Taloyoak Water Licence: 3BM-TAL 0813

RE: Technical Comments on 3BM-TAL 0813 - Type "B" Municipal Water Licence, Taloyoak

Explanation and respond to EPOD Letter dated January 06, 2014

Picture 5: Taloyoak Solid waste site

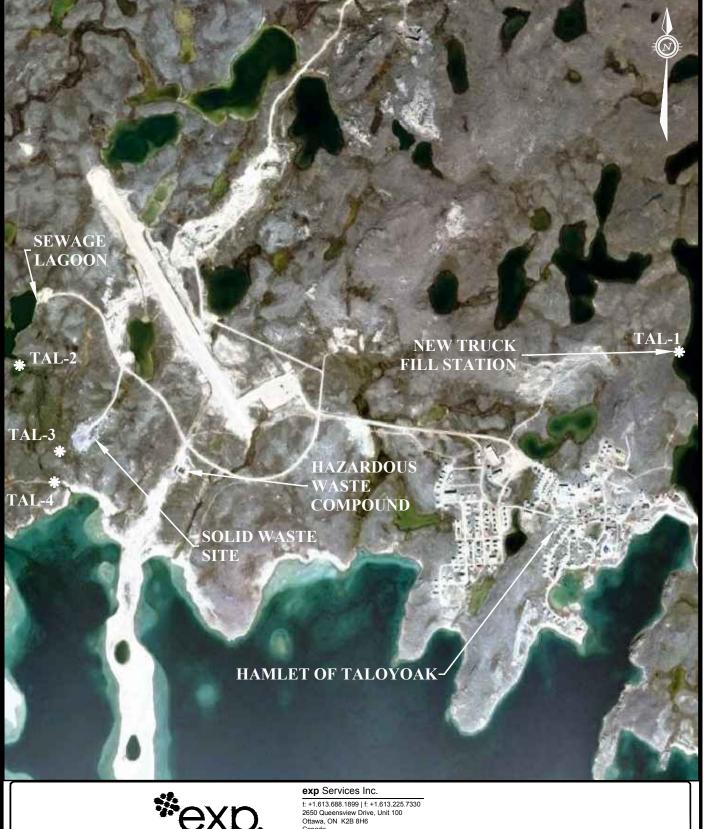
12. The solid waste facility is on an area of sloping topography – metal dump at one end and municipal solid waste at the other lower sloped end, secured with perimeter fence.
